Watts Bar Nuclear Plant, Unit 2
NRC Docket No. 50-391

**Subject: WATTS BAR NUCLEAR PLANT (WBN) UNIT 2 – REQUEST FOR
ADDITIONAL INFORMATION (RAI) REGARDING INDIVIDUAL PLANT
EXAMINATION (TAC NO. ME3334)**

Response to NRC Request for Additional Information Regarding IPE in June 23, 2010 Letter

Figure 3-1

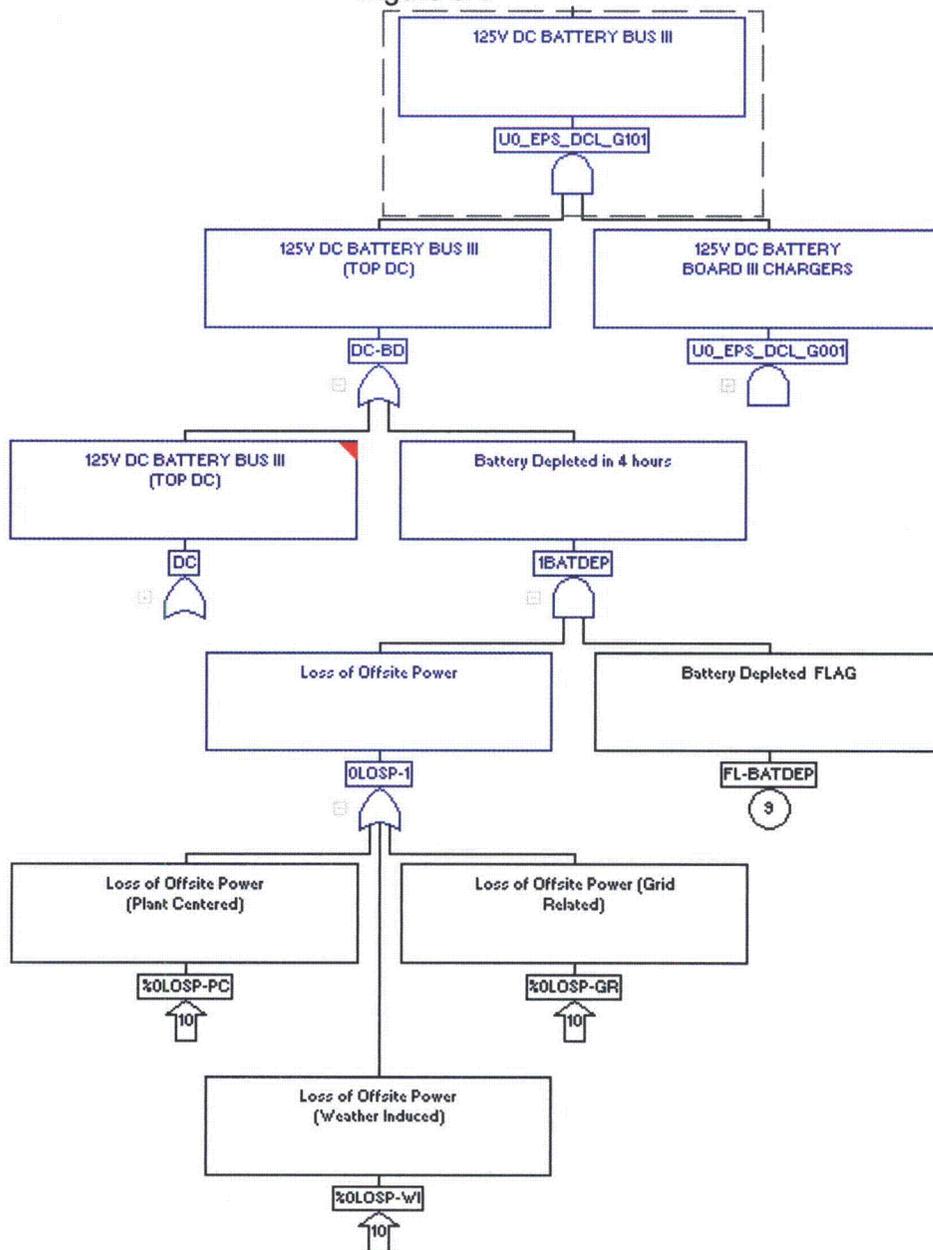
In the peer reviewed model, battery depletion was addressed in the model with an EQU gate containing all of Loss of Offsite Power (LOOP) IEs. The battery depletion gate is then applied into the model as a failure of the 125 Volt (V) DC vital battery boards. This logic incorrectly truncated the run failures of the Turbine-Driven (TD) Auxiliary Feedwater (AFW) pump and flow path.

Subsequent to the peer review, the battery depletion logic was revised and a basic event with a probability of 1.0 was ANDed with LOOP IEs under the battery depletion gate. Figure 3-1 displays the revised modeling for battery depletion. The revised model was requantified, and cutsets were reviewed to confirm that the delayed TD-AFW pump failures and battery failures were properly modeled.

To support the ongoing resolution of the second portion of this finding regarding the battery board dependencies, the 125V DC system models and loss of 125V DC battery board support system IE trees were reviewed. In the loss of battery board support system IE trees, the battery board failures are correctly modeled. Loss of a 125V DC board would result in loss of that train and results in an IE (e.g., BUSFR0BD_2361D_IE). After review of the 125V DC board system tops, it is recommended that the failure of battery board basic events (e.g., BUSFR0BD_2361-D) be moved above the battery board gate and battery charger

Figure 5-13: Unit 1 Flood-Initiator LERF Breakdown

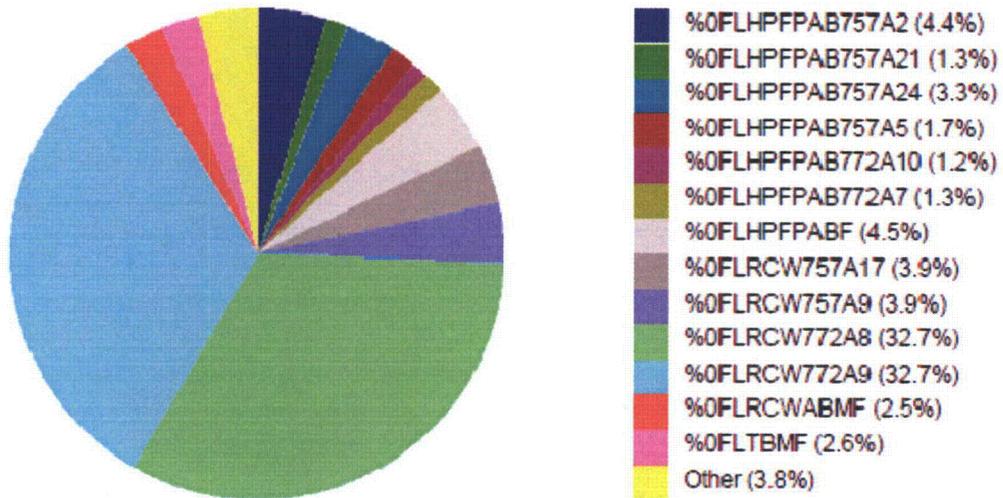
It is not clear how the peer review could indicate that SR IFQU-A10 was met when F&O 7-8 clearly states that the peer reviewer could find no evidence that the LERF analysis included internal floods. Further, in order to understand how and ensure that a more quantitative understanding of the overall probability of fission product releases was achieved, it is important that the PRA model addresses the potential contributors (e.g., internal flood). Provide a more complete description of how IF contributes to the LERF sequences (e.g., the development of event trees, event sequences, timing, etc.).

The IF impact is essentially superimposed on the base-line (i.e., no flood) PRA model and relies on the event trees and associated sequences already developed for the no-flood PRA base-line model. Flood-specific results are provided for both units. These results included both CDF and LERF. Major contributors to the flood only portion of CDF and LERF for both units are provided at the end of this response for the aforementioned table and the Figures 5-13 and 5-15 associated with LERF results. Because of the way the WBN IF-PRA is modeled, a specific flooding event tree is not used; a utility code injects flood-specific IEs and associated logic directly within the one-top linked fault tree model. WBN IF-PRA defines each flood scenario analyzed by defining the direct impact and the set of indirect impacts (more details on the indirect impacts, such as the specific failed components). The flooding logic was mapped to existing initiators that follow the general transient event tree. Specific sequences were then dictated by the specific direct and indirect failures and evolved into common plant damage states that were binned accordingly with the methodology and the criteria specified in the WBN PRA Level 2. IF initiators (i.e., GTRAN initiators) were binned either in Bin 1 or Bin 2. The modeling structure takes into account that some accident sequences may be common to both bins; these events are grouped with the most conservative bin via the model structure. The LERF values were based on the model containing IF. Specific event sequences (i.e., CDF cut sets) were discussed in the WBN PRA Quantification notebook and were not replicated in the IF-PRA notebook.
